ARCHITECTURAL REVIEW BOARD STAFF REPORT

Project #/Name	ARB-2020-28: North Point Community, North Entrance – Sign
Review Type	Certificate of Appropriateness for a Sign
Parcel Identification	03200-00-00-02000
Location	On the east side of Rt. 29 across from Northside Drive
Zoned	Planned Development Mixed Commercial (PDMC)/Entrance Corridor (EC)
Owner/Applicant	CWH Properties Limited Partnership / Great Eastern Management Company (David Mitchell)
Magisterial District	Rivanna
Proposal	To install a freestanding sign in the median of the entrance to the subdivision. The proposed location in the VDOT right-of-way requires a Special Use Permit.
Context	Significant clearing and grading of the site has occurred. The surrounding area includes a mix of wooded and cleared land, single family residences, and small commercial buildings.
Visibility	The sign will be readily visible from the EC street. Mock-ups of the sign pedestal and sculptures are in place.

ARB Meeting Date	June 15, 2020
Staff Contact	Margaret Maliszewski

3 SIDE ELEVATION (WIDEST SIDE OF SIGN)
SCALE : 1:2

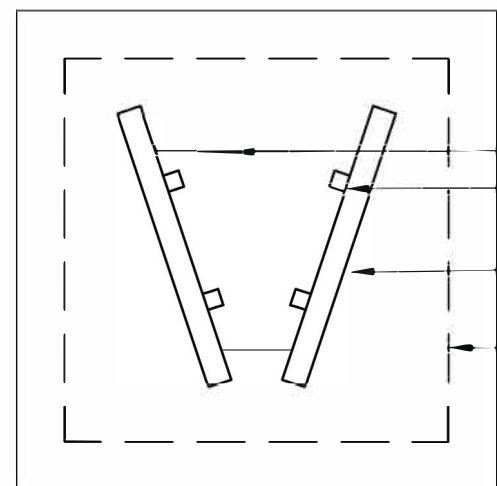
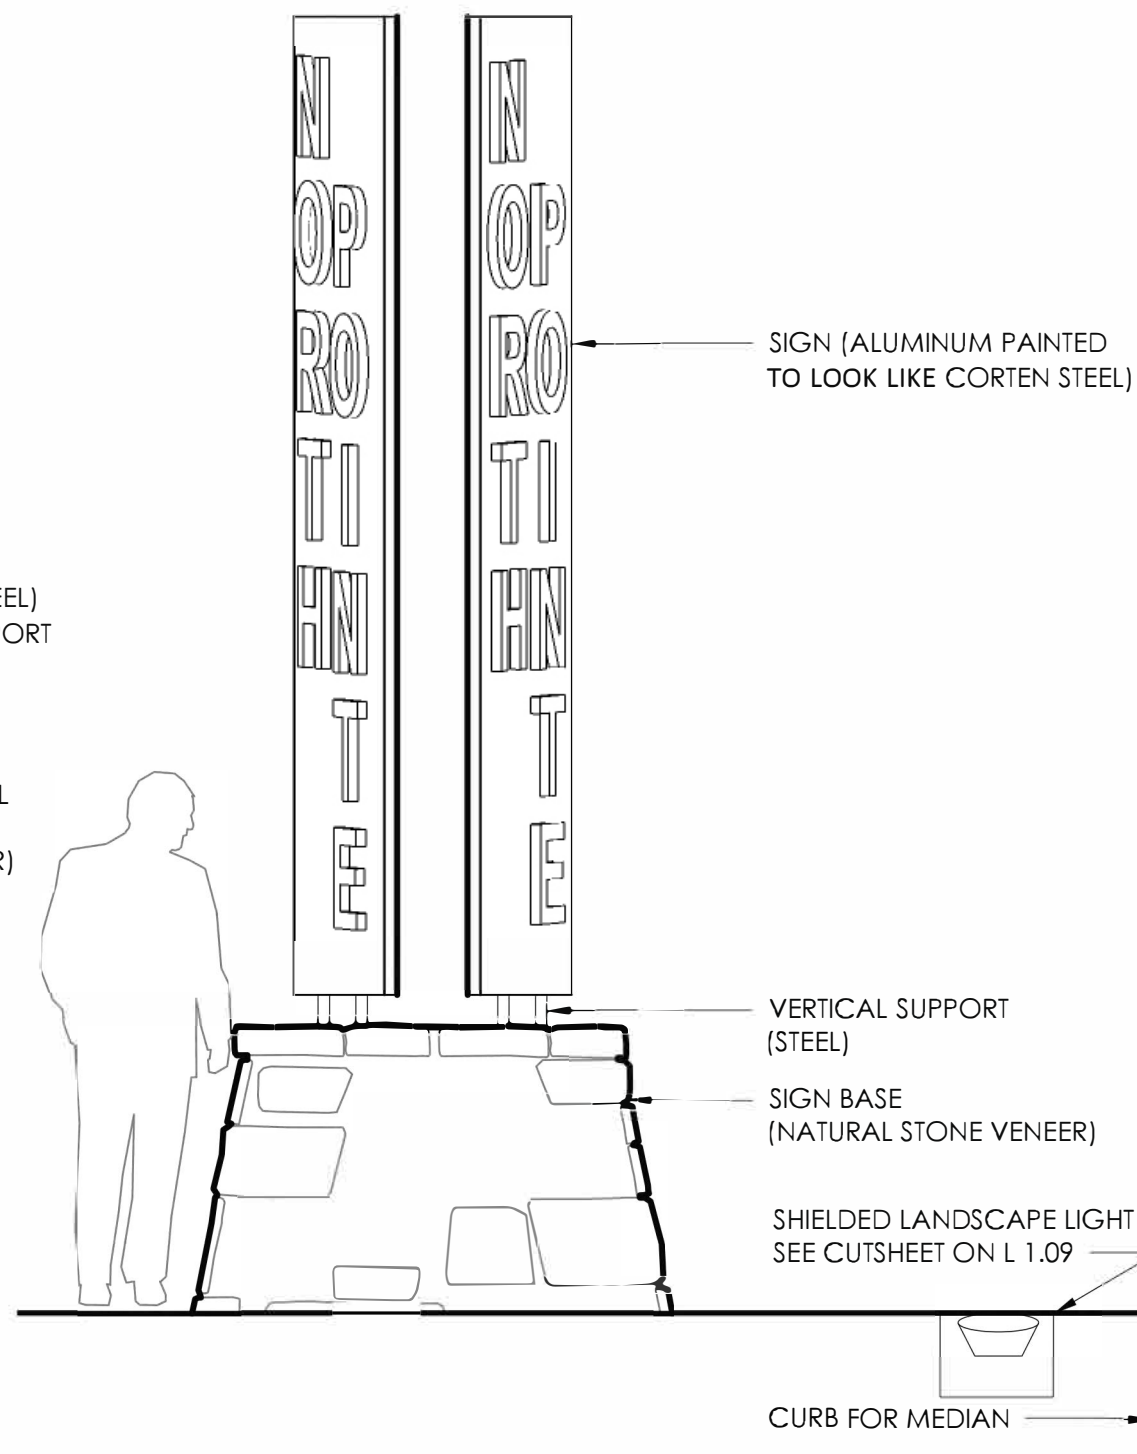
REF	GUIDELINE	ISSUE	RECOMMENDATION
4b	Scale and Size: Signs located within the Entrance Corridor may not exceed the size, height and setback requirements as outlined in Section 4.15 of the Albemarle County Zoning Ordinance (unless the sign has received a variance).	Overall sign height is proposed at 13'6". This includes a 3'-tall base and 10'3"-tall sign panels. 16' is the maximum allowed height in this zoning district. Proposed sign area is 31.5 sf, which meets ordinance requirements. The sign is proposed in a public right-of-way; consequently, a Special Use Permit is required.	None.
1	Create a consistent and unified design approach along the Entrance Corridors. The <i>placement, size, illumination and colors</i> of signs can create unity along the corridor, or they can create a disjointed, visually competitive environment. Consistent and unified sign design allows the businesses located along the Corridor to have equal standing in visibility. It also provides a pattern of sign placement that makes the business locations and entrances more easily recognizable to both vehicular and pedestrian traffic.	Proposed sign materials include stone (natural stone veneer) for the base and aluminum panels painted to resemble corten steel as backer panels for channel letters. The stone base is intended to match the stone retaining walls approved along the EC street, extending north and south from the site entrance, although this is not noted on the drawings. The designs of buildings to be located nearby have not yet been submitted for review.	Add a note to the drawings stating that the stone for the sign and sculpture bases will match the stone approved for the walls along Rt. 29.

REF	GUIDELINE	ISSUE	RECOMMENDATION
	complexity, and distance from and relationship to the Entrance Corridor. These factors will determine the extent of internal illumination that can be approved.		
5e	External Illumination: Lighting should be shielded and not create glare. Lighting should be aimed so as not to project illumination beyond the sign. All external light sources shall be white.	The ground-mounted fixtures are proposed with “narrow flood” optics. The manufacturer’s information indicates that precise aiming is available.	Add a note to the sign drawings stating that the ground-mounted fixtures will be aimed to illuminate only the sign.
8e	iii. Internal illumination: Channel letters with translucent faces shall be constructed such that no light spills outward from the top, bottom, sides or back. If back-lit (halo-lit), the faces and returns of channel letters shall be opaque.	The sign drawings indicate that the letter returns are to be opaque.	None.

1. Add a note to the drawings stating that the stone for the sign and sculpture bases will match the stone approved for the walls along Rt. 29.
2. Limit lighting to external fixtures that illuminate the entire sign.
3. Add a note to the sign drawings stating that the ground mounted fixtures will be aimed to illuminate only the sign.
4. Revise the planting plan to show low landscaping at the base of the sign, coordinated with other nearby planting.

VIEW FROM RTE 29, NORTHBOUND

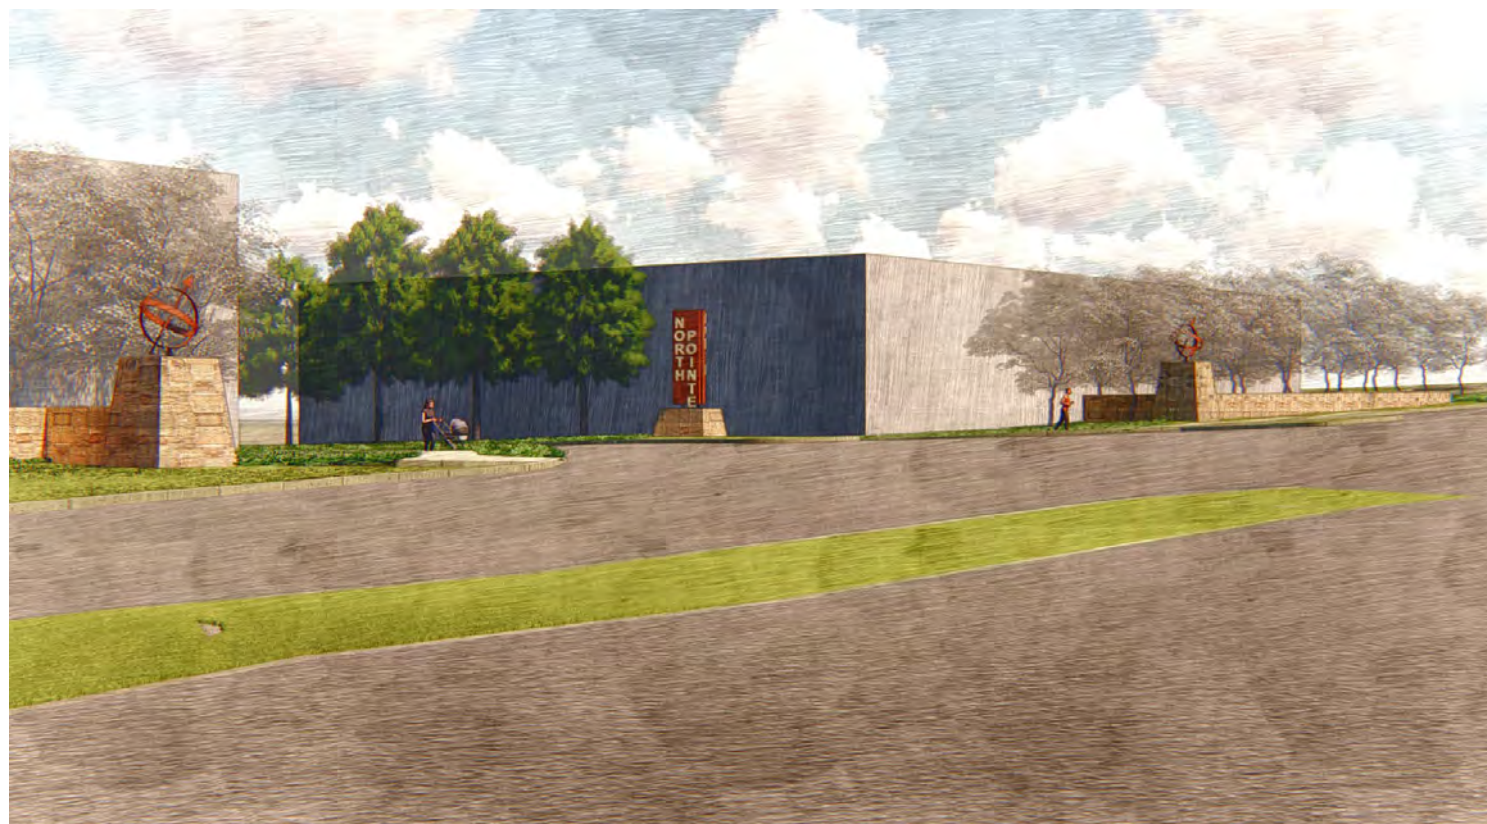
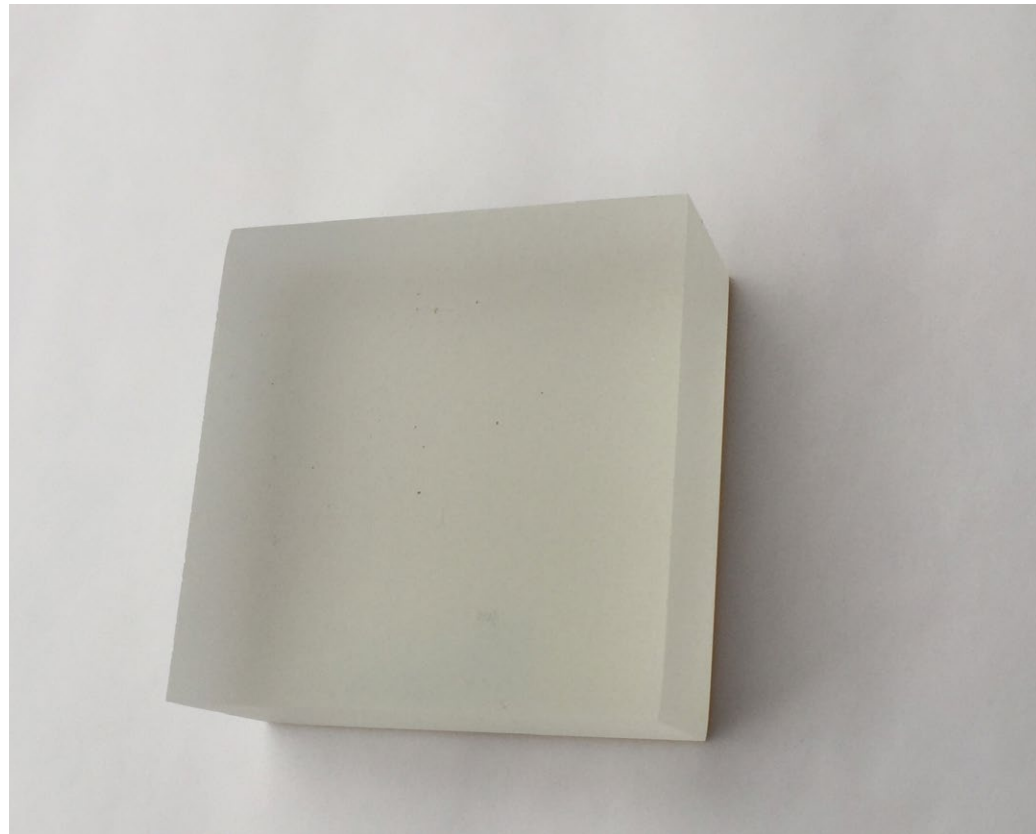
4f	Trademarks, corporate logos and graphics: The ARB may require that the color and scale of standard templates for trademarks, service marks, corporate logos and graphics be modified. When used, trademarks, service marks, corporate logos and/or graphics should be incorporated as an integral part of the overall sign.	The proposed sign does not look like a trademark design.	None.
5	Lighting: The purpose of ARB review is to ensure that new development in the Entrance Corridors is compatible with the historic architecture of the County and to promote orderly and attractive development. There is no historical precedent for internally illuminated signs. However, the ARB recognizes the need to identify businesses to help the traveling public find their destination and exit	The proposed sign is both internally and externally illuminated. The channel letters that are attached to the metal panels have internal illumination that shines through the letter faces. The	Limit lighting to external fixtures that illuminate the entire sign.

REF	GUIDELINE	ISSUE	RECOMMENDATION
	the highway safely.		
5a	When illumination is required, the preferred solution is to externally illuminate the sign – in other words, to shine a light on the sign. External illumination is preferred because it allows consistency with the daytime image of the sign. External lighting appears to the viewer as reflected light and allows the focus of the sign to be the original overall shape, color and complete design of the sign. Internal lighting produces a fragmented, rather than unified, sign image at night compared to external lighting and may project light that is distracting to the viewer. Similarly, exposed light sources that form the body of a sign (such as, but not limited to, exposed or bare neon) are not appropriate for the Entrance Corridors. They can produce glare and, generally, do not achieve the subtle character and compatibility that is the goal for the Entrance Corridors.	plan also shows 2 ground-mounted lights at the base of the sign with LED lamps (2100 lumens) that have a warm white color. Two additional fixtures are proposed at the bases of the sculptures. Internal illumination is typical for channel letters, but channel letters are more typically used for wall signs. External illumination can help maintain a consistent image for the sign from daytime to nighttime (by making the entire sign visible at night), but it isn't entirely clear what impact the external illumination will have on this sign when combined with the internally illuminated channel letters. There is a potential that the channel letters will appear as a bright glow, disassociated from the panels, from a distance along the EC street. Limiting lighting to external lamps that illuminate the entire sign would provide for a consistent, unified image.
